APPENDIX R REPAIR, ALTERATION, AND CONVERSION TO TANK CAR TANKS

Fig R.4.A POSTWELD HEAT TREATMENT THERMOCOUPLE PLACEMENT AND USE

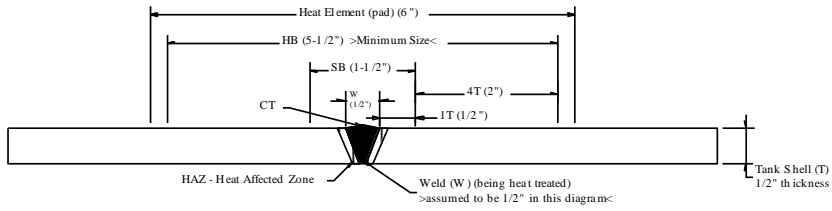
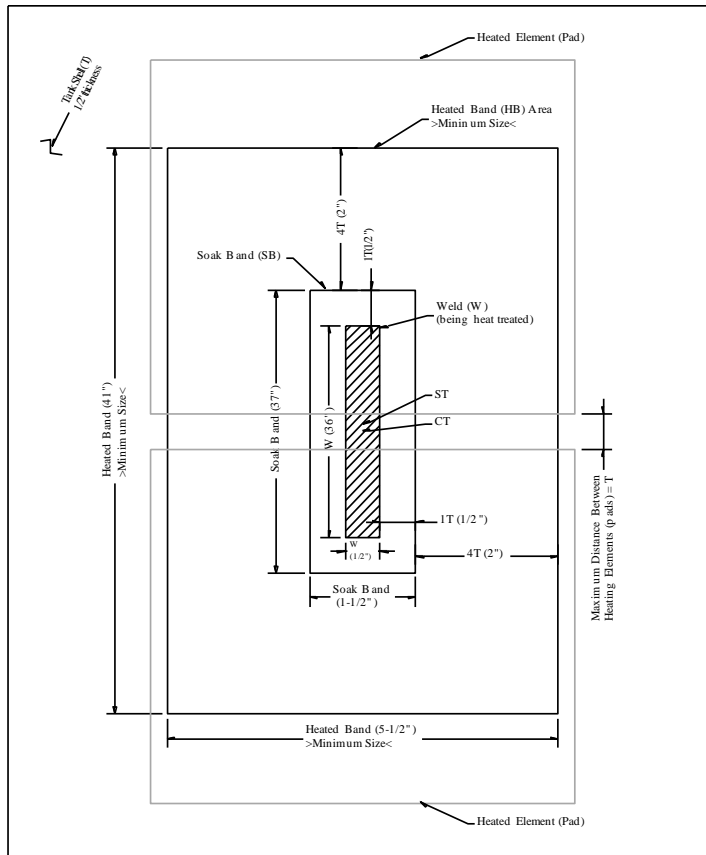
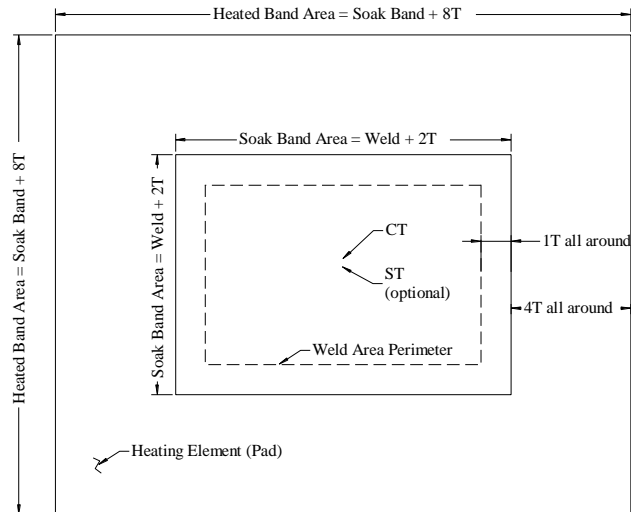
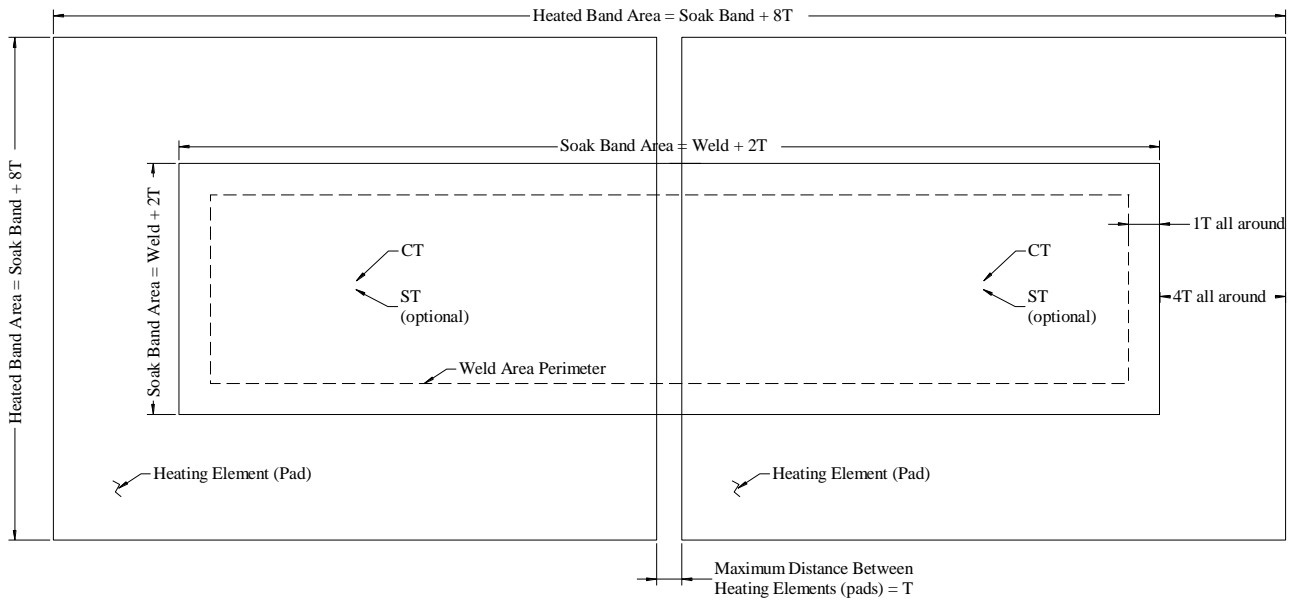
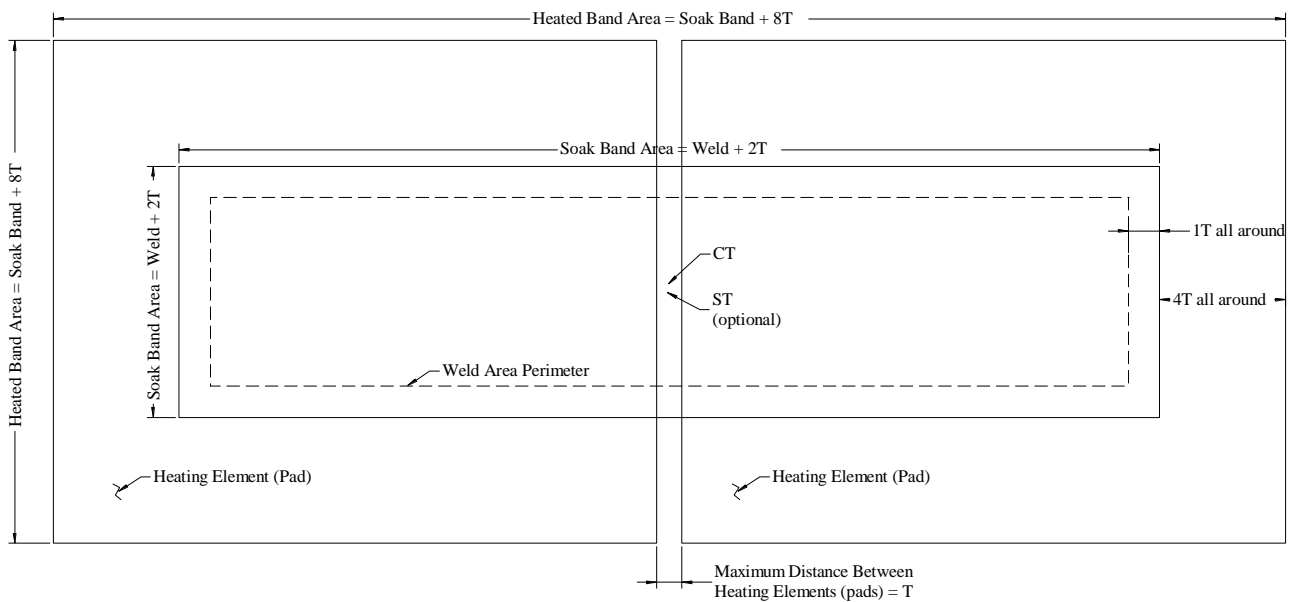
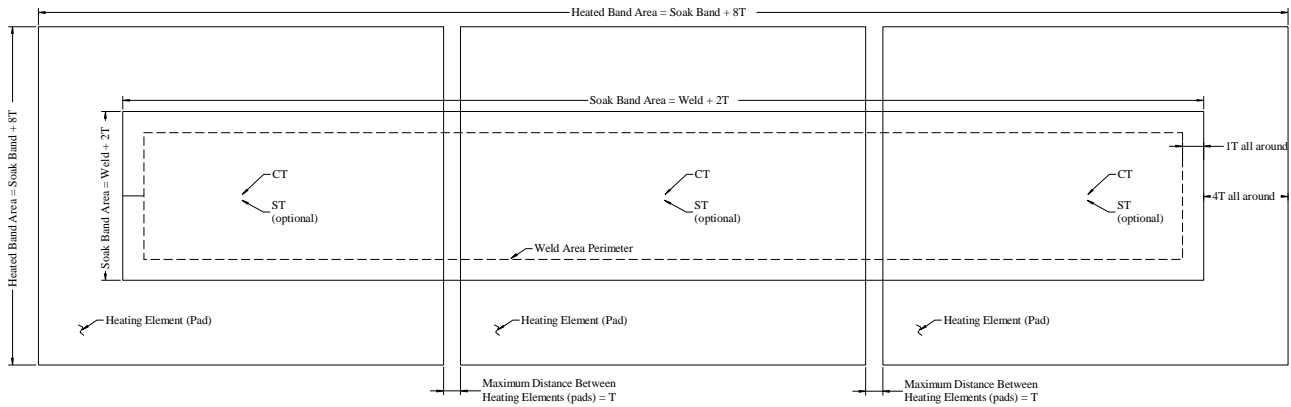
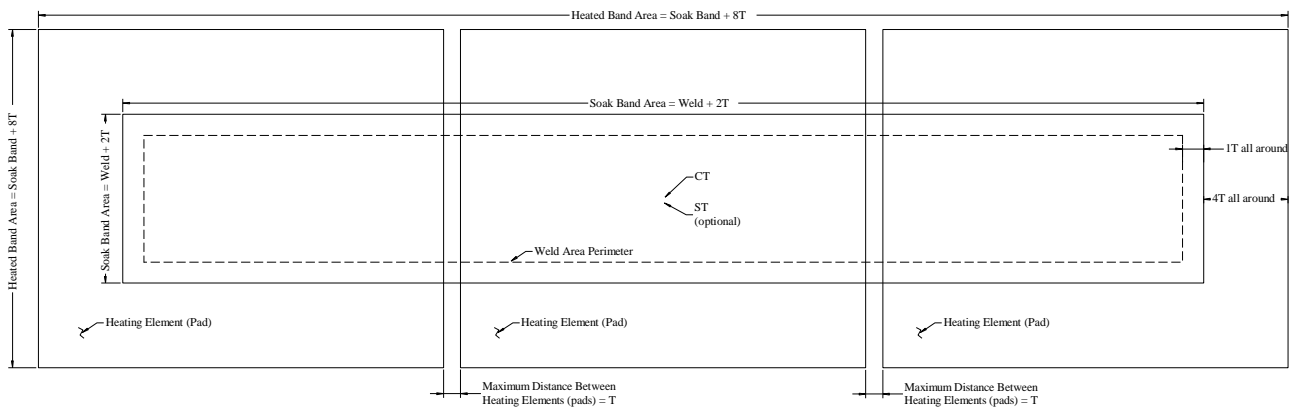
19.3.2.2.1 Heaters are to be positioned such that the LPWHT heating soak band (SB) meets the PWHT temperature requirements listed in Table W16.0, and the heated band (HB) extends past the soak band ~~extends past each edge of the weld~~ a distance of ~~six~~ four times the shell thickness minimum. For electrical resistance heating, the spacing between heating elements shall be no more than the nominal tank shell thickness. See figure R.4. Heaters and the opposite side of the heating area are to be covered with thermal insulation to reduce heat loss.

~~19.3.2.2.5 When required, monitor thermocouples are to be located a distance equal to or less than six times the nominal shell material thickness from the edge of the weld. See Figure R4 for monitor thermocouple requirements. Control and monitor thermocouples are to be located to~~

Local postweld heat treatment may be used, provided that the minimum heated area includes ~~at least six times the tank or head plate thickness on each side of the weld.~~ the soak band (SB) and heated band (HB) as defined in Figure R.4. The temperature distribution must be controlled as follows:

Fig. R.5 Welding fractures

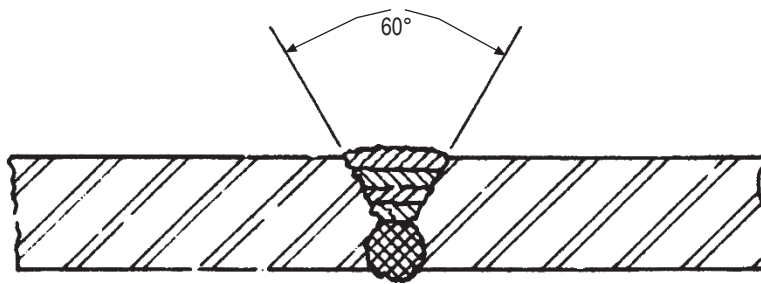
9.1.1 For cracks determined to progress through the thickness of the tank shell, By preparation and welding of the crack shall be in compliance with Fig. R.5. A interior or exterior reinforcement patch may be applied over the repaired area, if deemed necessary.
